**ELECTRONIC REPORT TO GEORGES RIVER LOCAL PLANNING
PANEL FOLLOWING DEFERRAL AT 4 April 2019**

LPP Report No	LPP011-19	Development Application No	DA2018/0368
Site Address & Ward Locality	80-84 Regent Street, Kogarah Kogarah Bay Ward		
Proposed Development	Demolition of all existing structures on site and construction of a 11 storey residential flat building over three and a half (3.5) levels of basement parking containing sixty four (64) residential units and sixty nine (69) car spaces.		
Owner	Watsong Pty Ltd		
Applicant	Regent Street Property Pty Ltd		
Planner/ Architect	Planner: City Plan, Architect: PBD Architects		
Date of Lodgement	05/09/2018		
Submissions	Amended plans being notified from 26 September 2018 until 11 October 2018 - 1 submissions received. The height plane information submitted to satisfy the deferral reasons was not notified as the clarification of the height was 4.228m rather than 4.6m as nominated, therefore reducing the impact.		
Cost of Works	\$17,775,250.00		
Local Planning Panel Criteria	The application is a residential flat building subject to State Environmental Planning Policy No 65

Figure 3 - Height Plan diagram

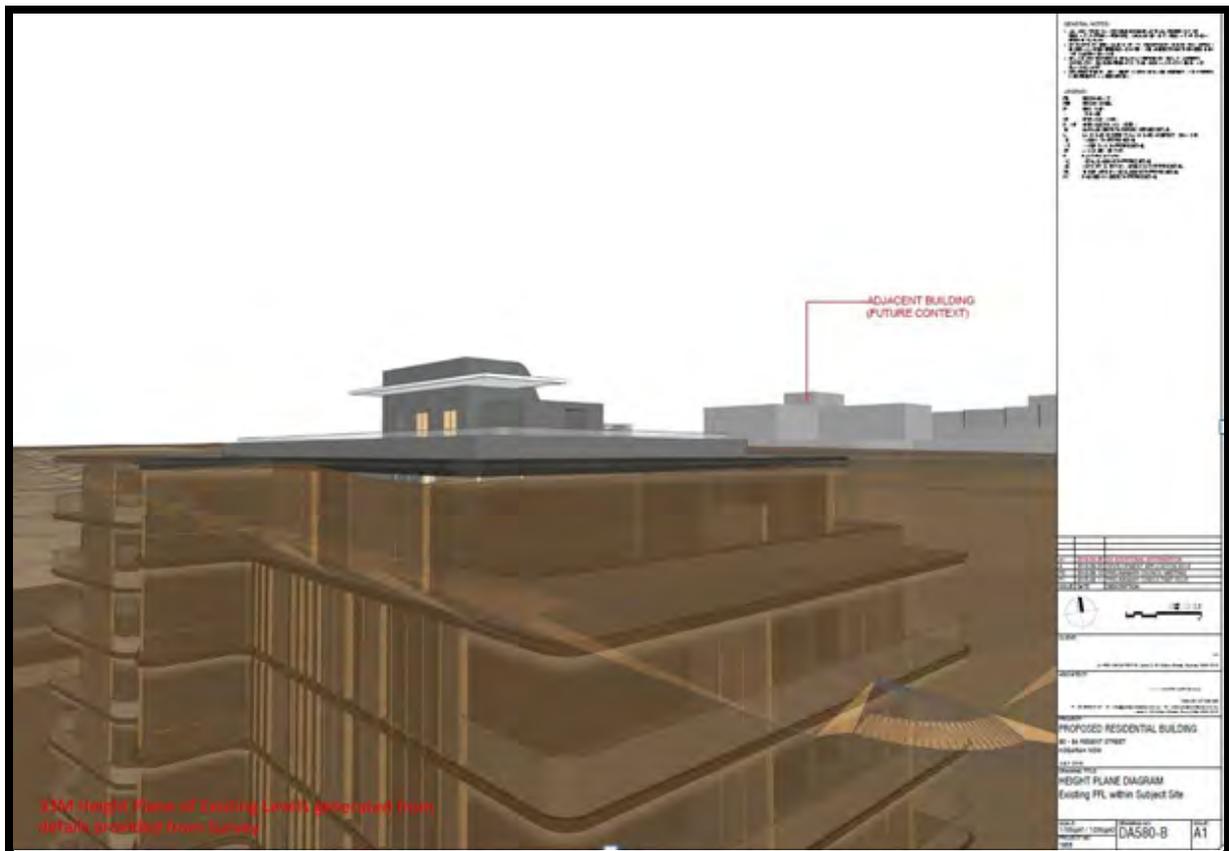
The extent of the variation is related primarily to the lift over-run of the building, the lightweight structures for the communal open space, stairs to the communal open space and amenities for the communal open space area. These structures provide equitable access to the proposed communal open/covered terrace on the rooftop and are limited primarily to the centre of the building.

parapet. The figure above shows the roof plan superimposed on the survey below). However, it is predominantly the roof parapet, and above which encroach the height as can be seen.

As is demonstrated, the extent of window encroachment is negligible and hidden below the roof parapet. The proposal will deliver an appropriate built form that is consistent with the desired future character as outlined in the Kogarah Local Environmental Plan and the Apartment Design Guide.

Officer Response: The height standard in this circumstance applies and is not excluded.

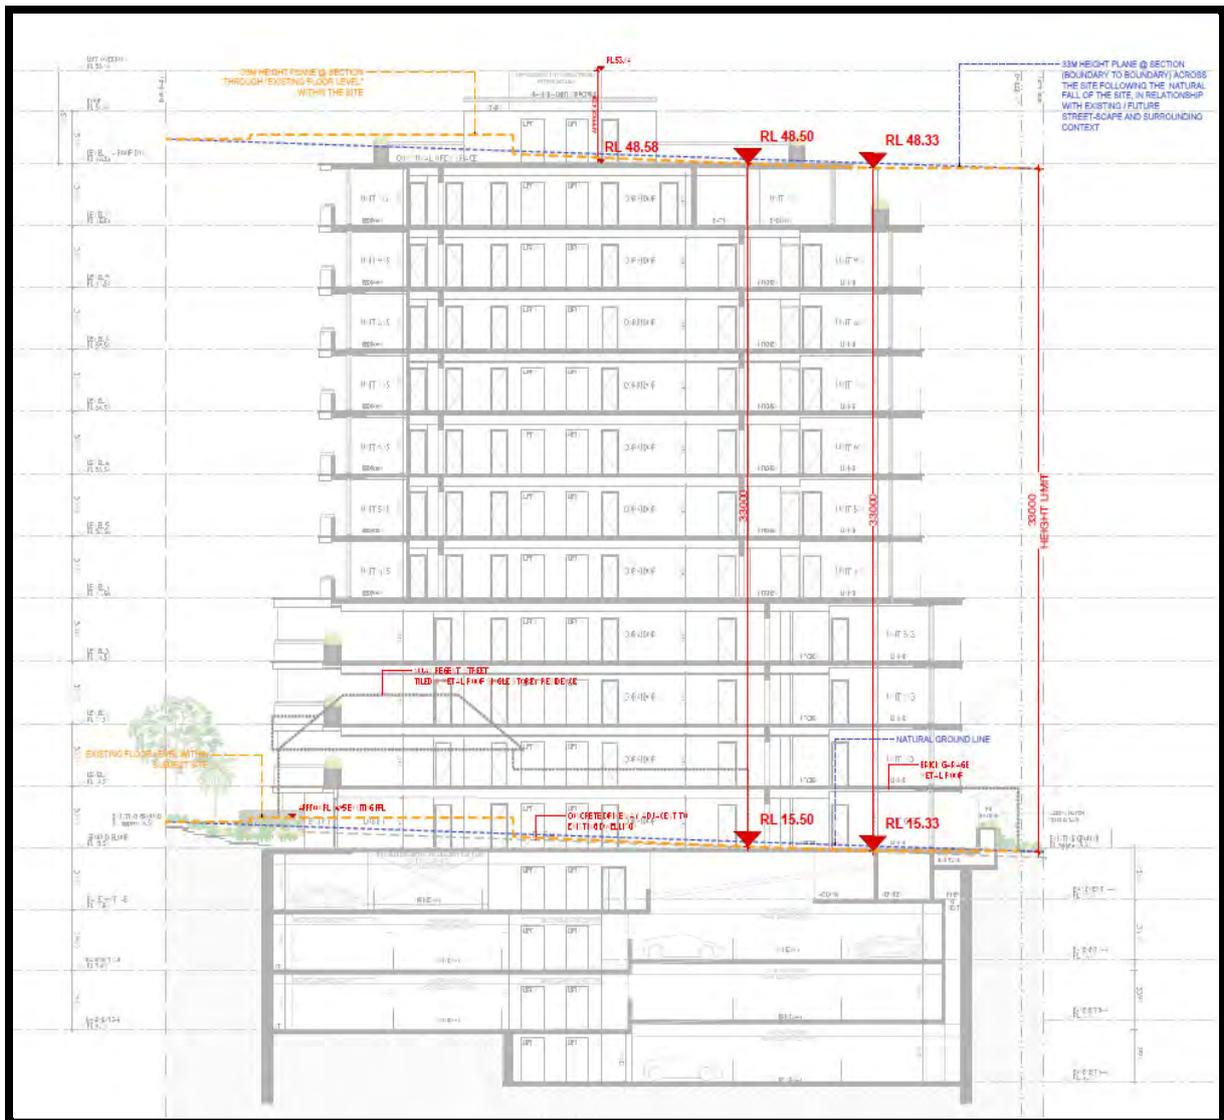
Applicant Response - *As discussed earlier, the proposed breach of the standard facilitates public benefits through a built form outcome that achieves the desired urban design principles established under the Kogarah North Precinct Urban Design Strategy. The proposal provides generous setbacks and articulation, resulting in a building that will provide an improved relationship*

Officer Response - The breach in question is considered to be of a minor nature and is limited to the provisions of the lift over run. Whilst Council, has permitted rooftop structures for communal open space including lifts over runs in the past to protrude within reason beyond the development standard, it maintained strict compliance however, ensuring that no breach contains residential components therein.
